# Staff Report

**To:** Salt Lake City Historic Landmark Commission  
**From:** Aaron Barlow, AICP, Principal Planner  
801-535-6182 or [aaron.barlow@slcgov.com](mailto:aaron.barlow@slcgov.com)  
**Date:** October 6, 2022  
**Re:** Petition PLNHLC2022-00297 – New Construction at 158 North State Street

## NEW CONSTRUCTION IN A HISTORIC DISTRICT

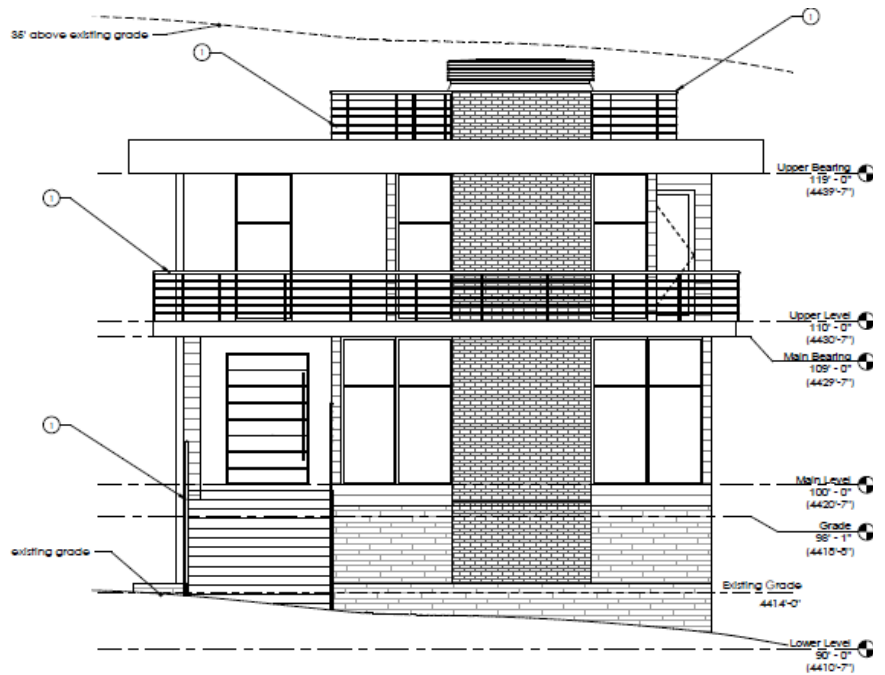
The applicants have proposed to construct a single-family house of modern architectural design. The proposed building would have two stories above grade and a partially submerged basement. The building would have a footprint of approximately 2,082 square feet. The building would sit 13 feet back from the front property line, consistent with the setback of the adjacent house and nearby properties. This would be a modification from the 20-foot front-yard setback required by the RMF-35 zoning district. The side-yard setback on the south side of the property would be five feet, also a modification from the required setback in the zoning district, which is 10 feet. Staff recommends approval of these modifications.

Parking for the proposed dwelling would be accessed from the existing driveway that is currently used by the existing dwelling and the house to the north at 170 East State Street (see site plan in [Attachment C](#)). The applicant has proposed an access easement through the rear yard of the existing dwelling to avoid the need for a driveway onto the adjacent state highway (which would not likely be permitted by the Utah Department of Transportation). Because the existing structure on the lot was converted from a triplex into a single-family house, the anticipated change in traffic from the proposed dwelling will likely be minimal compared to current conditions.

- The HVAC equipment near the southwest corner of the house shall either be moved or screened from view.
- Approval of all final design details, including specific direction expressed by the Commission, shall be delegated to Planning Staff.

FRONT ELEVATION

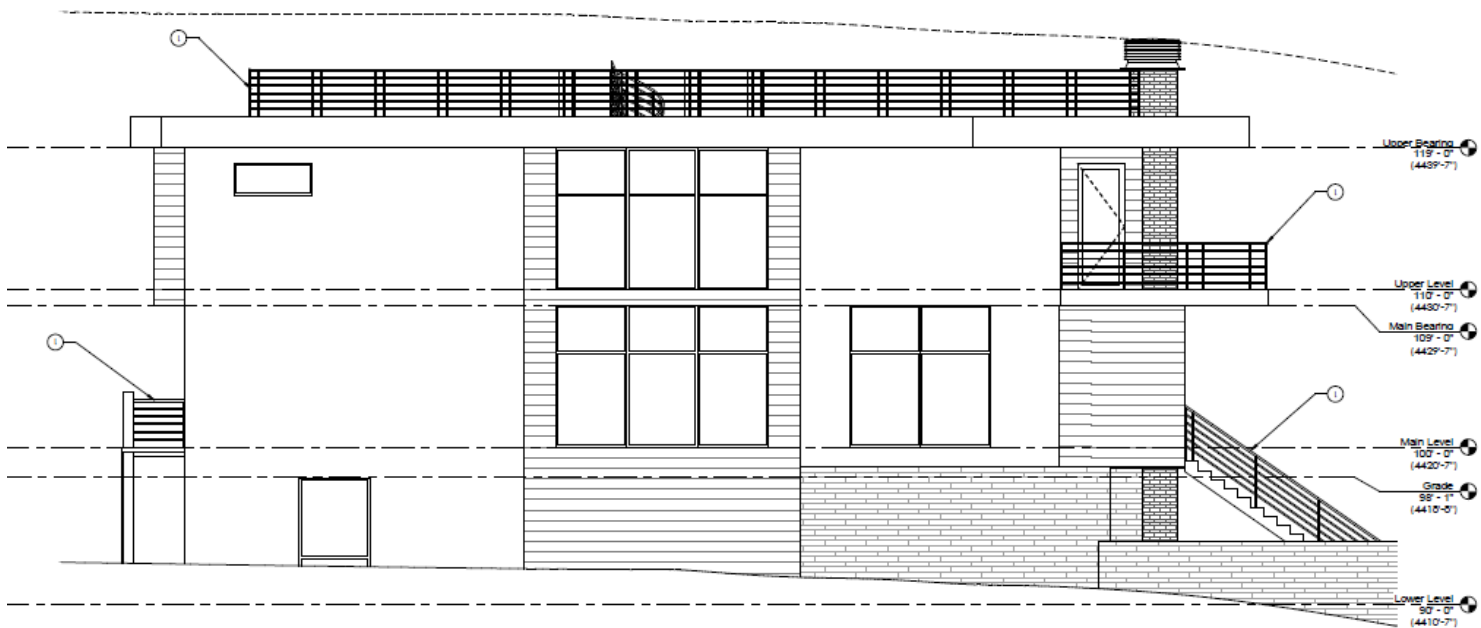
A wide chimney of dark brick sits near the middle of the front elevation of the proposed house, framed by floor-to-ceiling picture windows on the top two stories. Earlier iterations of the proposal had wider windows. Staff recommended that they be broken up to reflect the vertical emphasis of the existing building’s windows. Cedar siding fills up the remainder of the space on the elevation’s two upper stories. Except for the chimney and porch stairs, the base of the structure will be wrapped in white brick. A balcony wraps the second story of the building and another sits on the top of the building. Both will have railings with a horizontal design made of the 2-inch-thick tubing mentioned earlier.

LEFT ELEVATION

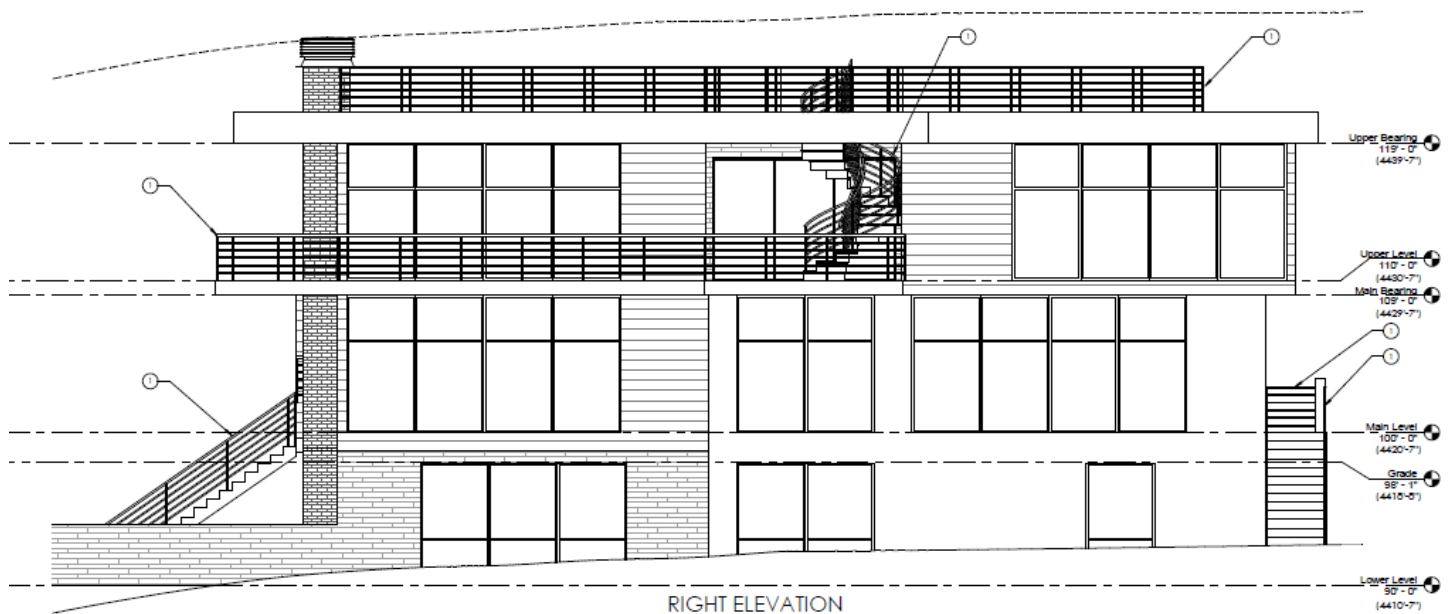
The side elevation to the east (facing the existing house) continues the pattern established by the front (white brick, cedar siding, and picture windows), but adds white stucco as you move towards the back of the building. The west elevation, which faces the park, also has a similar pattern, but with nearly a wall of windows. The applicants stated that because it is the “side of the house that people will see the most,” they wanted to “build a visually stunning house that has a lot of glass and character.” The house’s rear elevation will also have floor-to-ceiling picture windows and cedar siding on the second story. However, it will primarily be wrapped in white stucco.

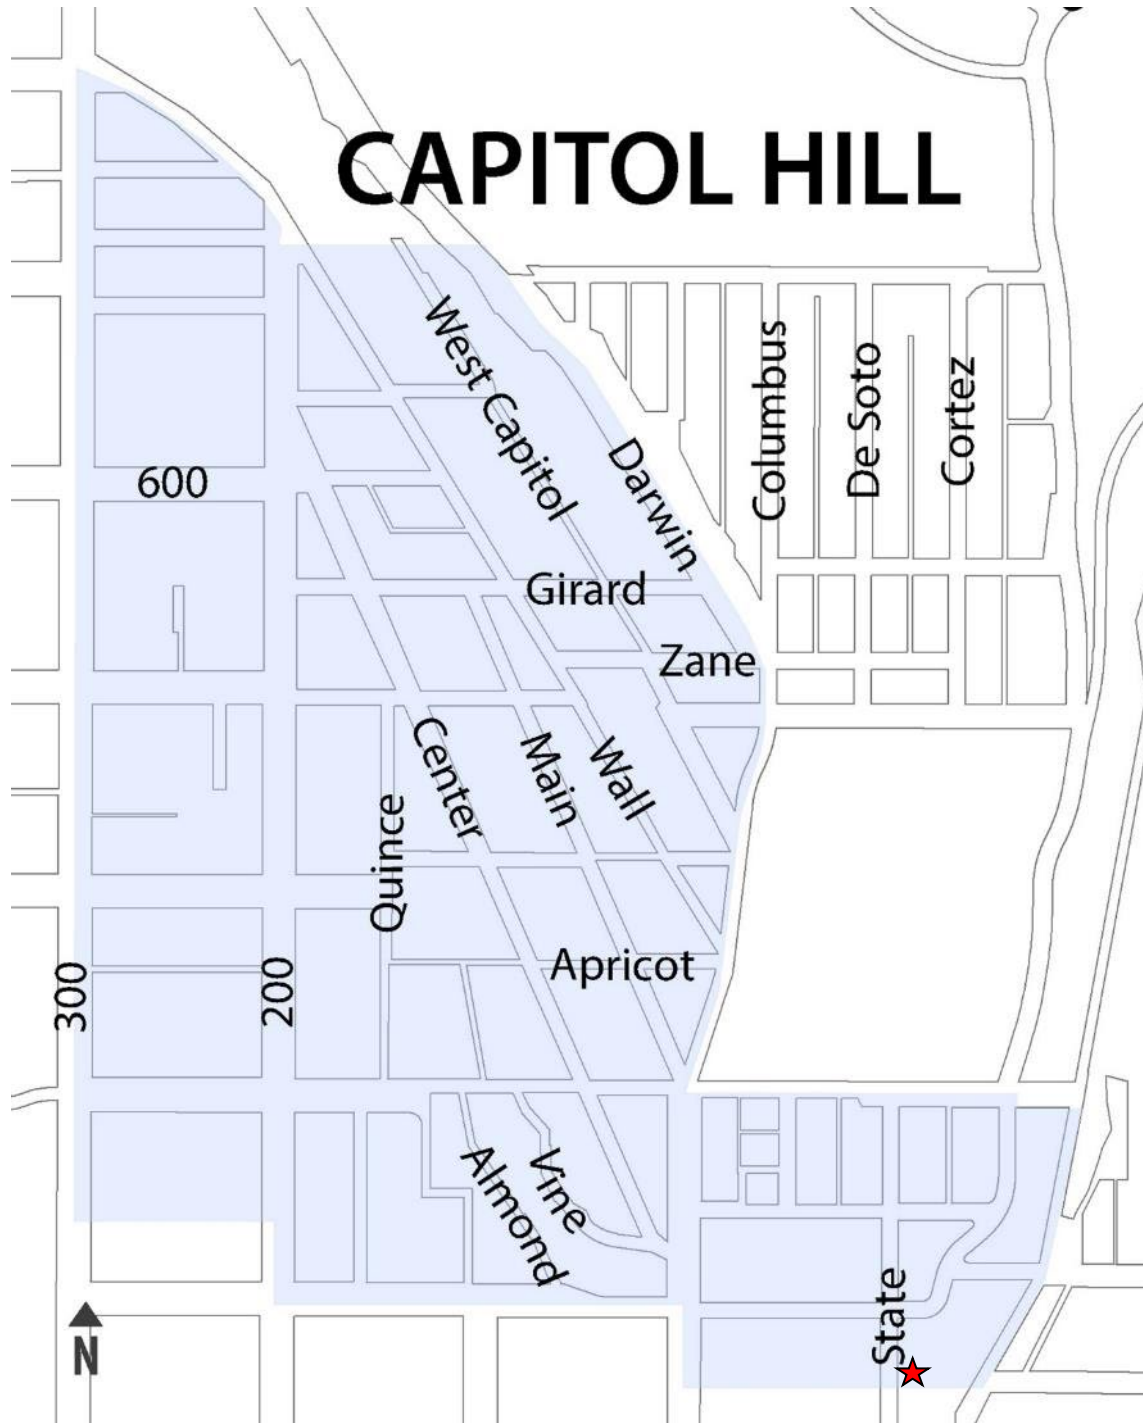
The proposed two-family dwelling complies with the adopted standards in 21A.34.020.H and Chapter 12: New Construction in the Residential Design Guidelines. The applicant worked with staff to make numerous modifications to the initial proposal. Renderings of the initial submittal and the current proposal are below for comparison. Changes made by the applicant include:

- Replacing the cantilevered basement with a bulkier base that reflects the scale of existing houses in the neighborhood
- Dividing the picture windows to add a stronger vertical emphasis to the facades visible from the public right of way
- Removal of a garage on the front of the house
- Reducing the size of the front door to better match the scale of surrounding properties
